IN THE MATTER OF AN APPLICATION TO
AN BORD PLEANÁLA

FOR APPROVAL OF THE FOYNES TO LIMERICK ROAD (INCLUDING
ADARE BYPASS) COMPRISING:

ABP Ref. ABP-306146-19 and ABP-306199-19

Brief of Evidence

Photomontage VP25: View north of River Maigue Crossing (above – existing landscape; below proposed view, post-mitigation); from EIAR Vol. 5A Photomontages

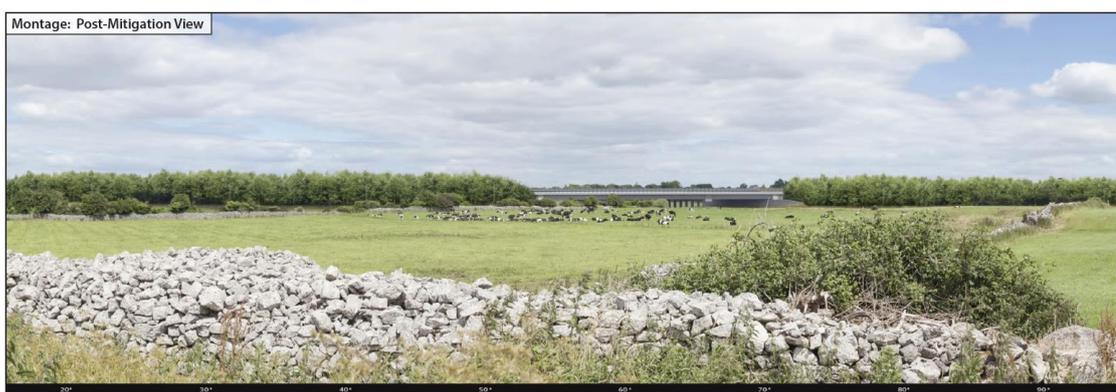
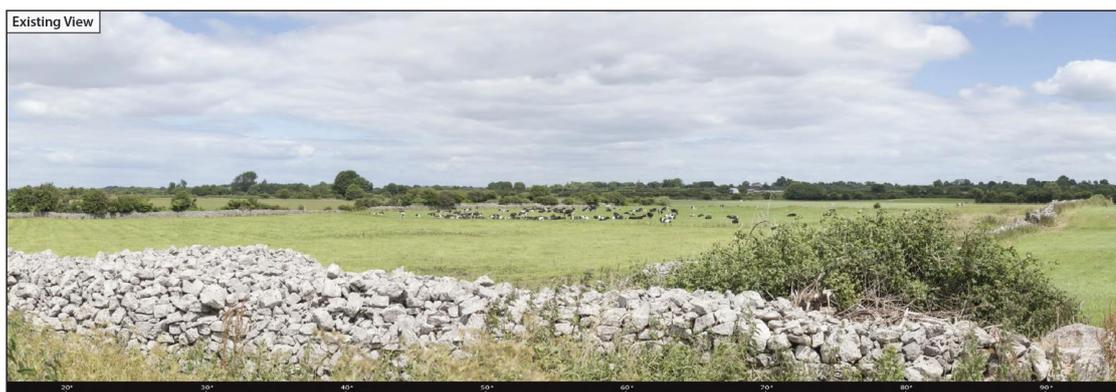
- 3.1.3 The proposed road will contrast with the existing countryside so will generate negative landscape impacts, but overall, after the new planting which is proposed for mitigation of negative effects establishes and helps to integrate the proposed road and structures, this is considered a slight negative impact in the wider landscape context. Moderate impacts will remain at the Maigue and Deel river crossings (see photomontages VP25 and VP6, respectively, below taken from Volume 5 of the EIAR).

**Photomontage VP1 View east from Knockpatrick Graveyard
from EIAR Vol. 5A Photomontages**

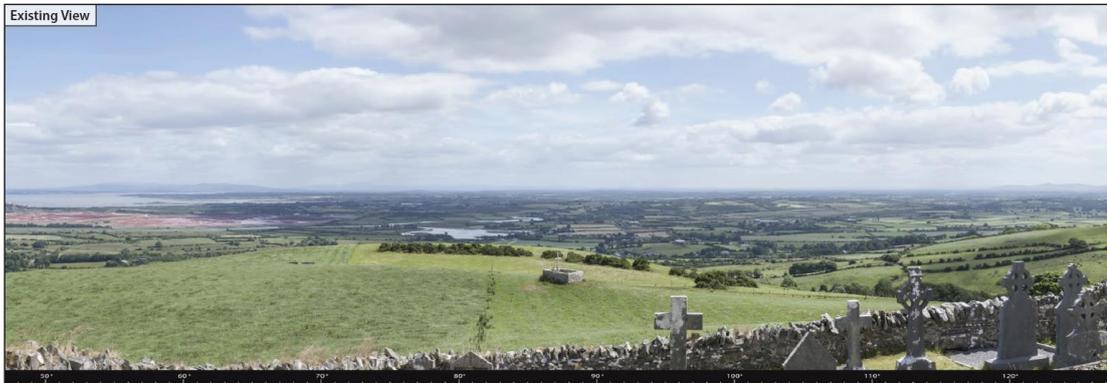
- 3.1.5 In general, the scenic quality of the study area is considered to be high, with lower values around settlements where linear housing along the roads reduces the quality of the landscape. However, due to the low-lying and undulating landform and the presence of mature hedgerows and trees, long distance views are often blocked or restricted and are rare in this area. There are very few public viewpoints in this landscape with sensitive views, as there are no parks or public amenity areas adjacent to the proposed road. The cemeteries at Knockpatrick and Rathkeale are considered to be the most sensitive public areas. At Knockpatrick, see VP 1 below, the elevated view will be slightly negatively affected, as – although the proposed road will be visible – it only takes up a small part of the panorama from this location. At Rathkeale Cemetery, see VP 13 below, the proximity of the proposed road and Rathkeale
